**PLANNING COMMISSION AGENDA
CITY OF PRAIRIE VILLAGE
MUNICIPAL BUILDING - 7700 MISSION ROAD
TUESDAY, MARCH 1, 2011
Council Chambers
7:00 P. M.**

TO: Prairie Village Planning Commission
FROM: Ron Williamson, Lochner, Planning Consultant
APPLICATION: PC 2011-103: Request for Approval of a Monument Sign Approval
for Office Building at 7830 State Line Road.
DATE: March 1, 2011 Planning Commission Meeting Project # 01100240

TO: Prairie Village Planning Commission
FROM: Ron Williamson, Lochner, Planning Consultant
APPLICATION: PC 2011-104: Site Plan Approval 3931 W. 69th Terrace, Prairie Village Center
DATE: March 1, 2011 Planning Commission Meeting Project # 01100240

PC 2011-101 Revision to Request for Site Plan Approval, 4049 Somerset, Westlake Hardware – Outdoor Sales Area(s)

Job **Sign location plan**
File **Somerset Bldg.cdl**

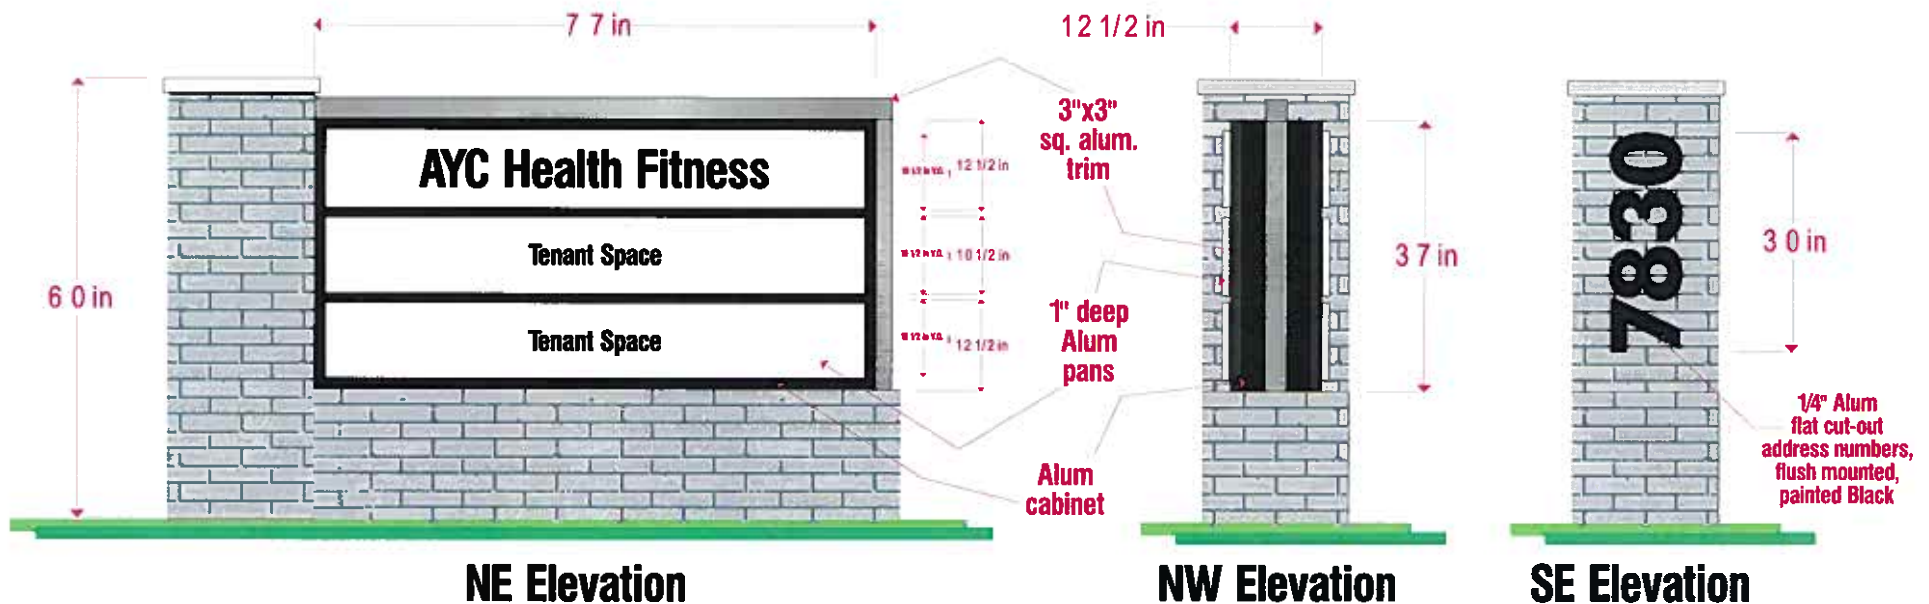
The minimum setback required by ordinance is 12 feet back from the back of curb and the sign must be on private property. The plan indicates the sign will be setback 12 feet from the back of curb from both State Line Road and Somerset Drive.

The drawing indicates the base will be made of the same brick as the building but the sign will be an aluminum cabinet. The aluminum cabinet does not meet the intent of the Planning Commission in its policy to allow multiple listing of tenants on monument signs for offices. Also this is the entrance to the City of Prairie Village and the design of the sign needs to be of a high quality.

The ordinance requires a minimum three feet landscaped area around the base of the sign and a landscape plan. The applicant needs to submit a detailed landscape plan identifying specific plant material that would be placed around the base of the sign for Planning Commission approval and the landscaping should be installed as part of the sign installation.

1. That the applicant prepare a detailed landscape plan identifying the specific plant materials that would be placed around the base of the sign for approval by the Planning Commission prior to the installation of the sign and install the landscaping at the time of sign installation.
 2. That the applicant submit a redesigned sign using the brick that is similar to the building and replacing the aluminum cabinet with a design that meets the Planning Commission policy.
 3. That the only signage approved for this office building is this monument sign and if any additional exterior signage is proposed on the building or otherwise, sign standards will need to be prepared for the building and submitted to the Planning Commission for review and approval.
-

SHEET NO:
AS101

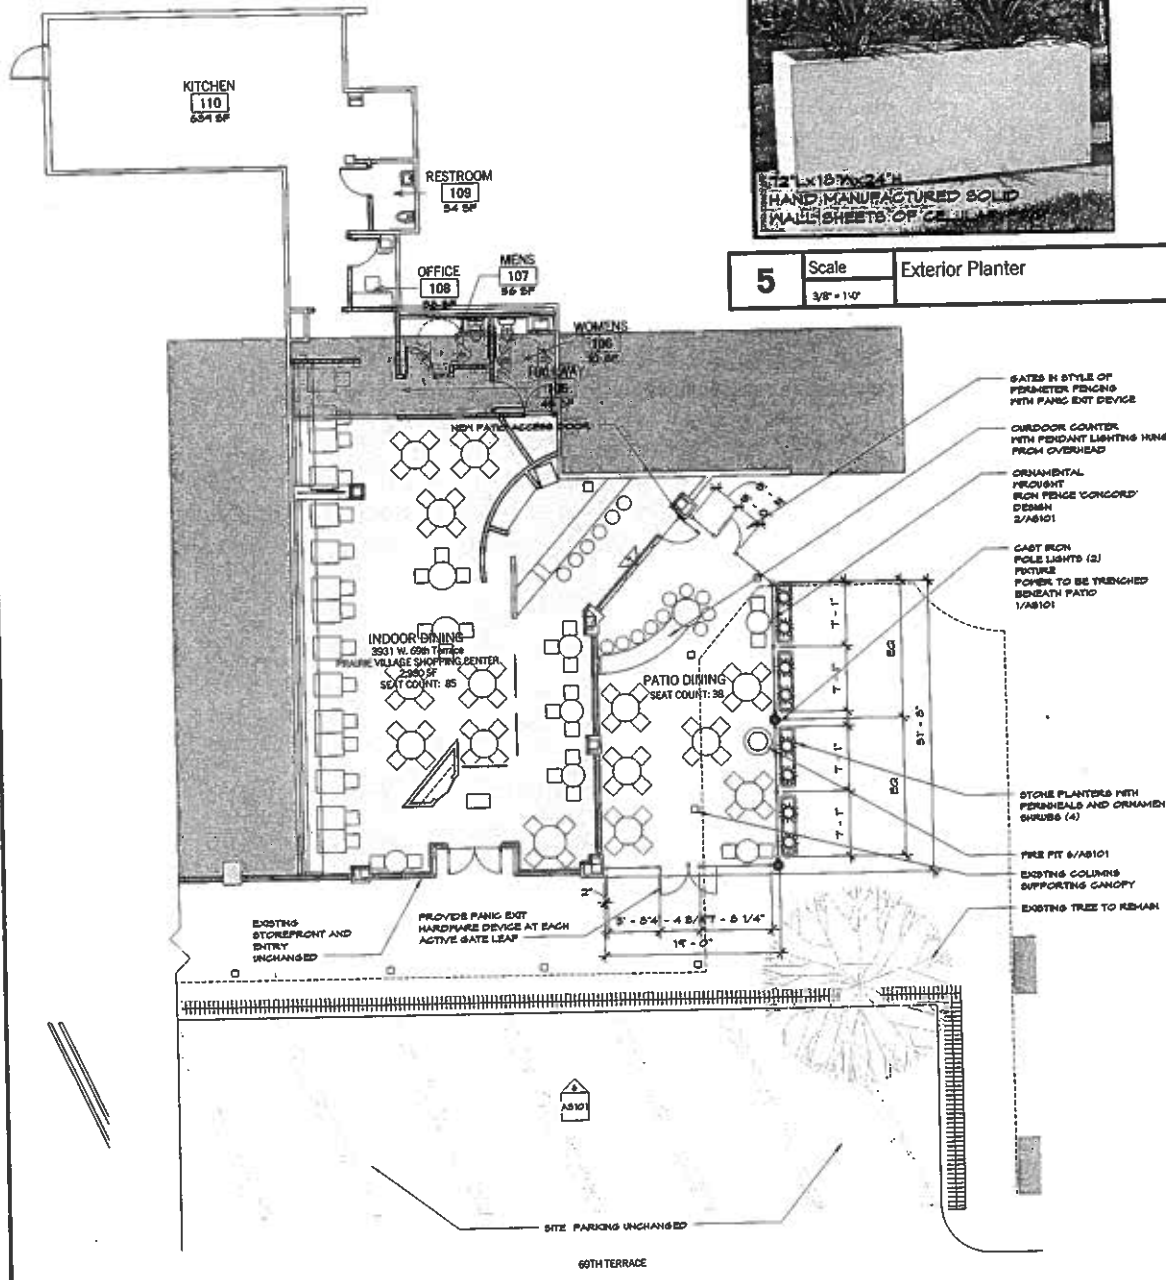
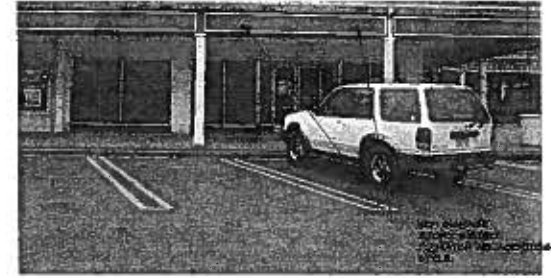
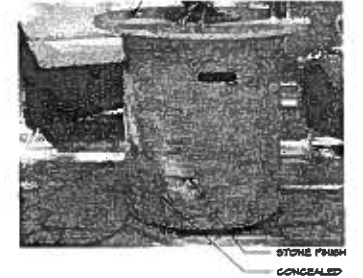
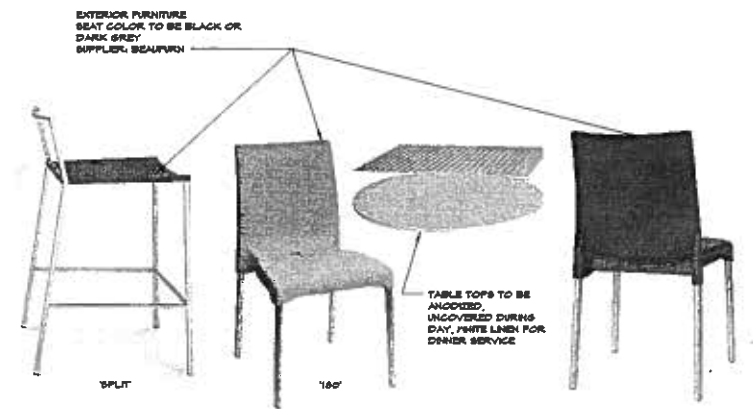
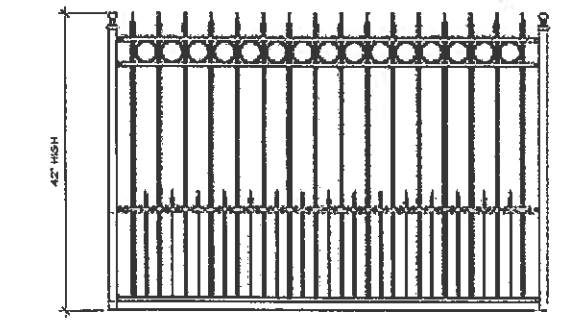
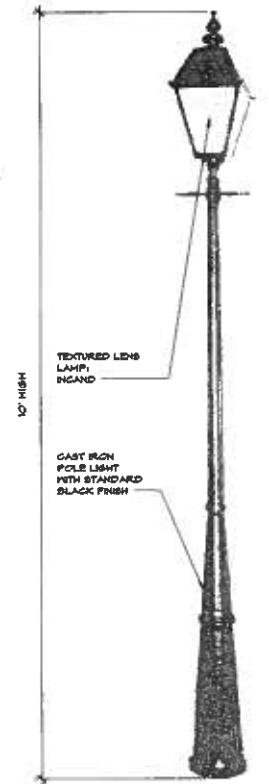
- A. The site is capable of accommodating the building, parking areas and drives with appropriate open space and landscape.**
The proposed site plan indicates the outdoor sidewalk location can accommodate the additional square footage for the outdoor eating area with very little affect on the center or the ability for pedestrians to circulate to other stores in this area. No new parking areas or drives are required for this use. This area is all hardscape and no landscaping is planned. However, it should be noted that four planters will be located on the west side of the patio area.

The addition of outdoor seating will help create a more vibrant atmosphere for the center and is consistent with good land planning practices. This is a good infill use of underutilized space in the Center. The pole lights propose a 100 watt Metal Halide lamp which may be a little bright. The architect is reviewing the fixture to determine if a lower wattage or different lens can be used to reduce the brightness.

- 1) That all lighting used to illuminate the outdoor area be installed in such a way as to not create any glare off the site and be in accordance with the outdoor lighting regulations.
- 2) That the fire pit meet all code requirements for use and storage of propane gas.
- 3) That the applicant submit planter details to Staff for review and approval.
- 4) That the outdoor area be approved for a maximum of 38 seats.
- 5) Prior to the approval of any future applications, Lane4 needs to update leasable square footage schedule and parking count and submit it to Staff.

Site plan showing the location of the proposed 20' X 20' tent structure

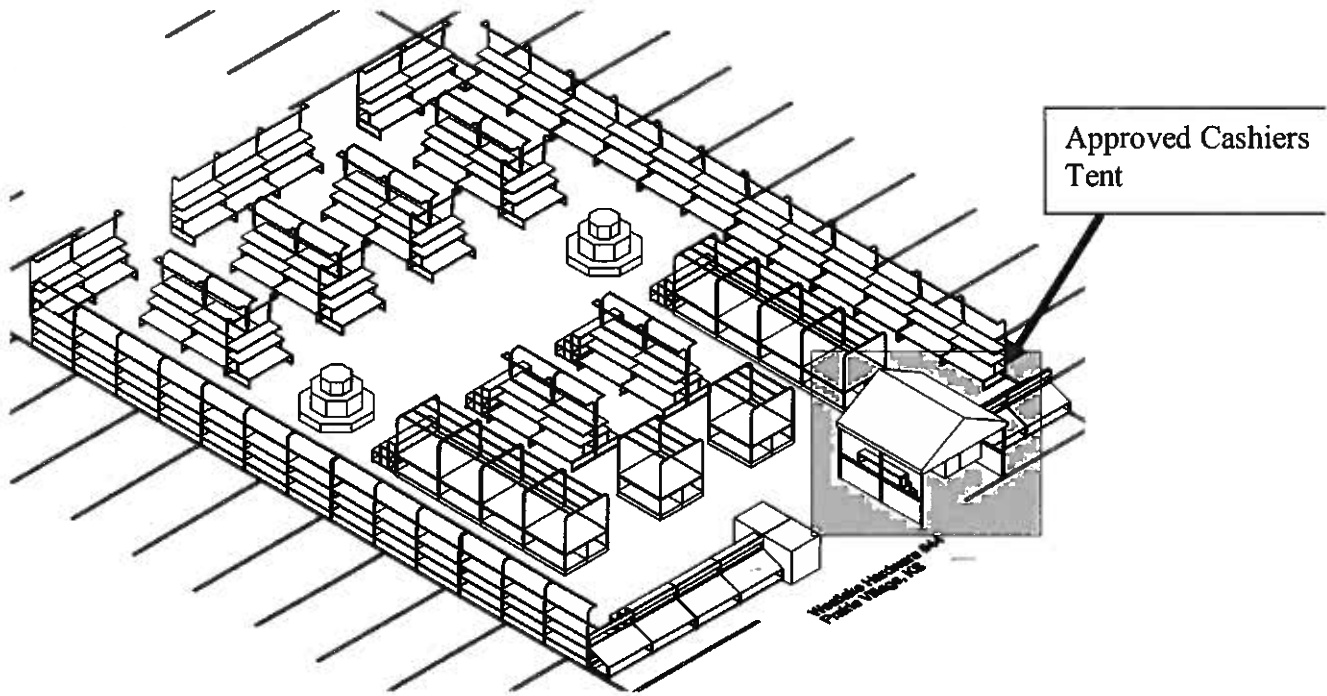
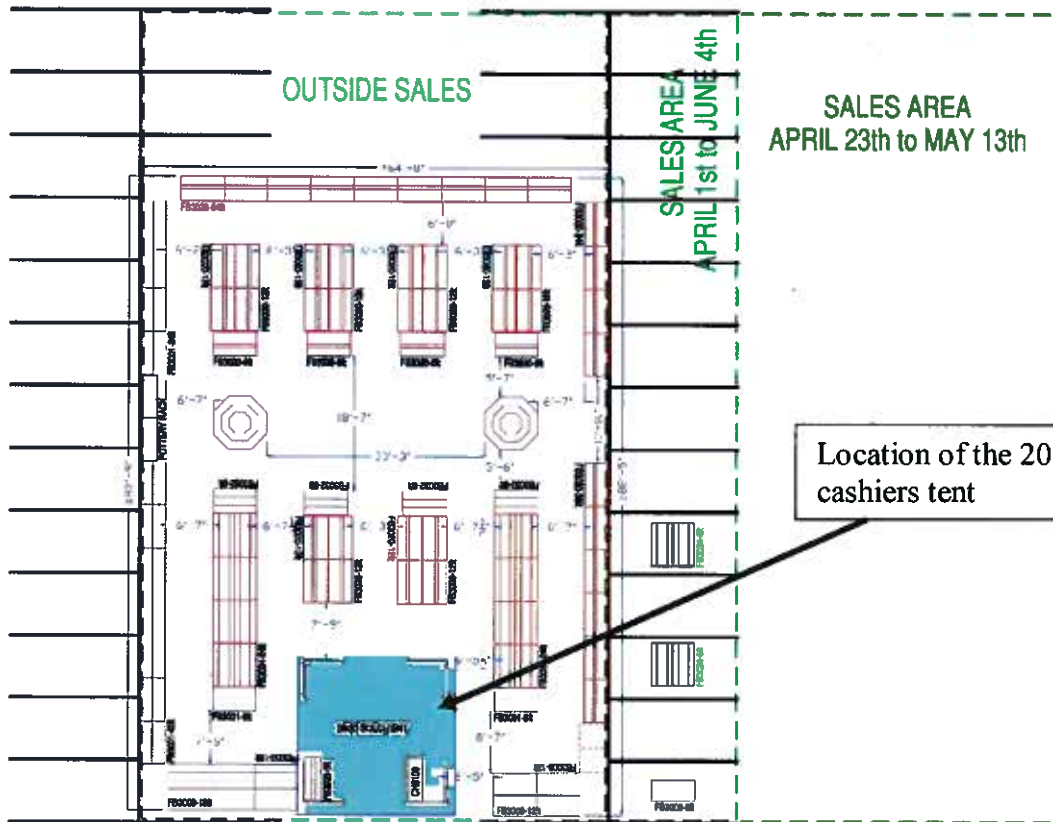
The original approval of the outdoor storage area included a covered cashier lane as shown in the attached drawing. Since the approval, the applicant has determined that they would like to have two exterior cashier lanes which would require a 20' X 20' enclosed tent structure (see attached photo of the proposed tent structure and a site location of the tent structure. Because the size of the tent structure has changed, staff is requesting that the Planning Commission review the proposed change.
